10/579,284

Office Action Summary	Application No. 10/579,284	Applicant(s) SCHLEGL ET AL.	
	Examiner MARINA TIETJEN	Art Unit 3753

DETAILED ACTION

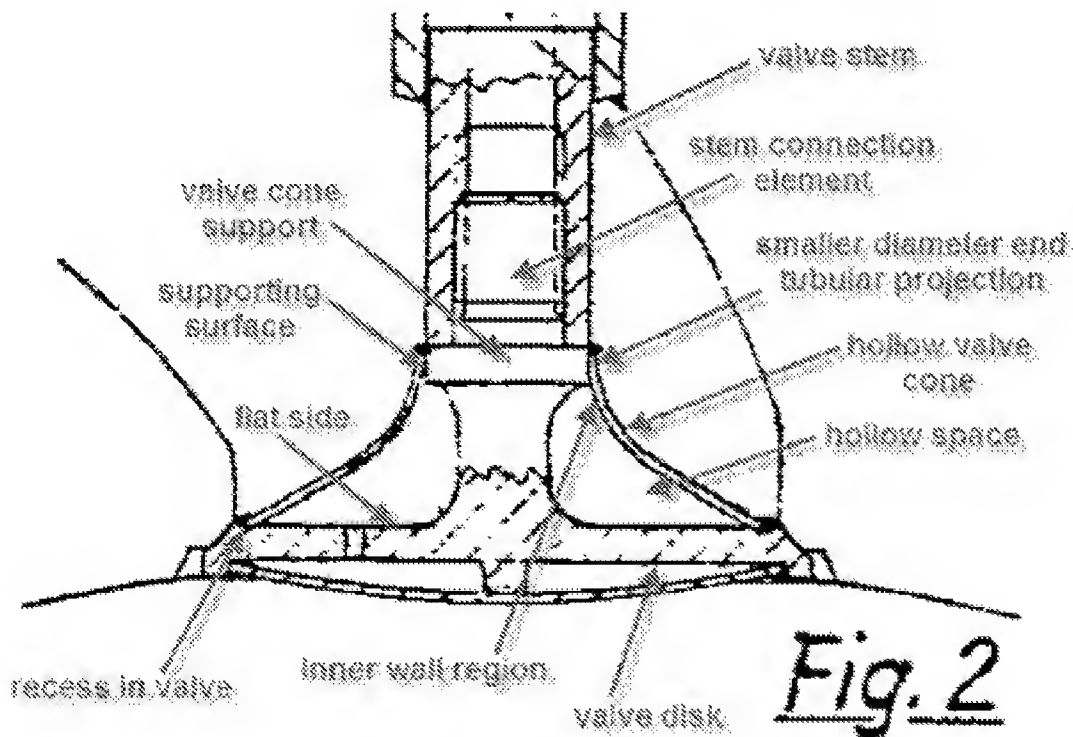
Schwaiger discloses a lightweight valve (fig. 2) comprising:

a valve stem (see labeled fig. 2 below);

a hollow valve cone (see labeled fig. 2 below) with a hollow space (see labeled fig. 2 below) having an end of greater diameter, the end having an inner circumference, an outer circumference and an end face between the inner circumference and the outer circumference; and

a valve disk (see labeled fig. 2 below) closing the hollow space (fig. 2) on one side and having a flat side (see labeled fig. 2 below) facing the valve cone (fig. 2);

the valve stem (fig. 2) being connected to a stem connection element (labeled fig. 2) formed on or fastened to the valve disk (fig. 2);

a valve cone support (see labeled fig. 2 below) located at a distance from the valve disk (fig. 2) and provided in the hollow space (fig. 2), the valve cone support (fig. 2) being located on the stem connection element (fig. 2) and projecting above the flat side (fig. 2);

wherein the valve disk (fig. 2) has a recess (vaguely shown in fig. 2, but better shown in fig. 6) serving as a centering and supporting seat for the valve cone (fig. 2);

wherein the valve cone support (fig. 2) includes at least one supporting surface (see labeled fig. 2 above) bearingly contacting an inner wall region (see labeled fig. 2 above) of the valve cone (fig. 2);

wherein a contour of the supporting surface (fig. 2) complements the inner wall region (fig. 2);

wherein the valve cone support (fig. 2) is formed by a thickening on the stem connection element (fig. 2);

wherein the valve cone is of disk-spring-shaped design (cone creates concave shape, fig. 2);

wherein the valve cone (fig. 2) has at a smaller diameter end (see labeled fig. 2 above) a tubular projection (see labeled fig. 2 above) for guiding through the stem connection element (fig. 2);

wherein the valve cone support (fig. 2) forms a centering and supporting seat for the valve cone (fig. 2); and

wherein the valve (fig. 2) is an internal combustion engine valve.

Figure 3

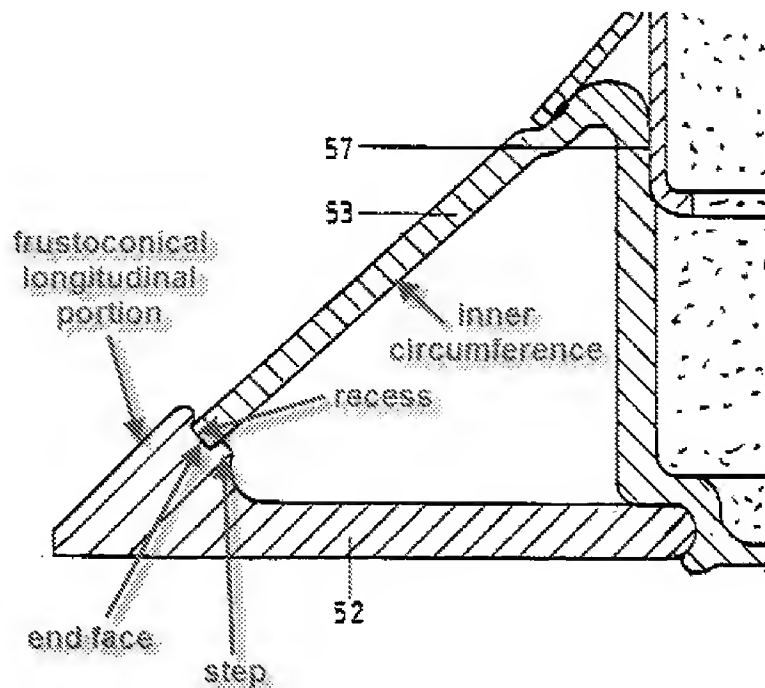
Leiber teaches means of attaching a valve cone (53) to a flat side of a valve disk (52), wherein the valve disk (52) has a longitudinal portion (upwardly protruding thicker portion along outer circumference of valve disk 52) extending from the flat side of the valve disk (52), the flat side of the valve disk and the longitudinal portion defining a recess (see labeled fig. 3 below) serving as a centering or supporting seat for receiving the end of greater diameter of the valve cone (53), the valve disk including a step (see labeled fig. 3 below) extending upward from the flat side of the valve disk, the step including an angled surface (surface contacting inner circumference of valve cone 53) that is angled with respect to the flat side of the valve disk, the angled surface supporting the inner circumference (see labeled fig. 3 below) of the end of greater diameter of the valve cone (53), the longitudinal portion supporting the end face (see labeled fig. 3 below) of the end of greater diameter of the valve cone; wherein the longitudinal portion is frustoconical in shape; and wherein a cone angle of the frustoconical portion of the valve disk is the same as a cone angle of the valve cone at

the end of greater diameter (as shown in fig. 3), for the purpose of providing art equivalent means for securing a valve cone to a flat valve disk.

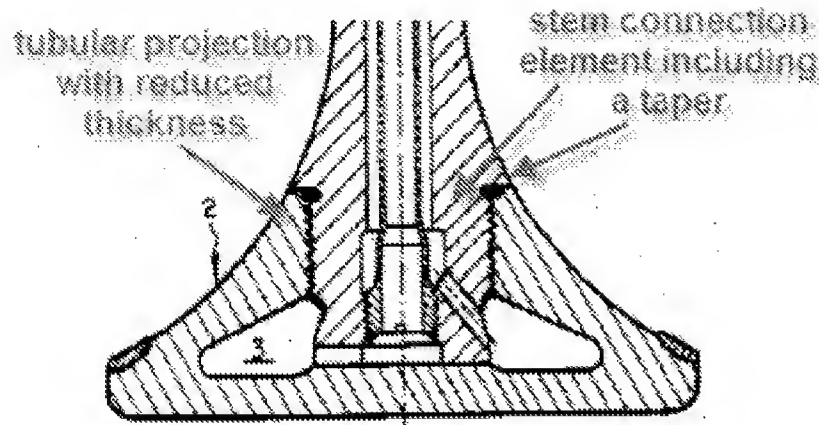
Schwaiger discloses the invention as essentially claimed, except for wherein the tubular projection has a reduced thickness in relation to a remainder of the cone so that the tubular projection nestles against the stem connection element, and wherein the stem connection element includes a taper receiving the tubular projection such that a continuous transition is formed between the tubular projection and the stem connection element.

Ysberg teaches a cone with a tubular projection (see labeled fig. below) having a reduced thickness in relation to a remainder of the cone (2) so that the tubular projection nestles against the stem connection element (see labeled fig. below); and wherein the stem connection element includes a taper (see labeled fig. below) receiving the tubular projection, for the purpose of providing a connection means which provide a smooth transition between the valve stem and the valve cone.

It would have been obvious to one having ordinary skill in the art at the time the invention was made to modify Meintschel's valve, such that the tubular projection is a reduced thickness in relation to a remainder of the cone so that the tubular projection nestles against the stem connection element; and wherein the stem connection element includes a taper receiving the tubular projection, as taught by Ysberg, for the purpose of providing an alternate equivalent means of connection which provide a smooth transition between the valve stem and the valve cone.
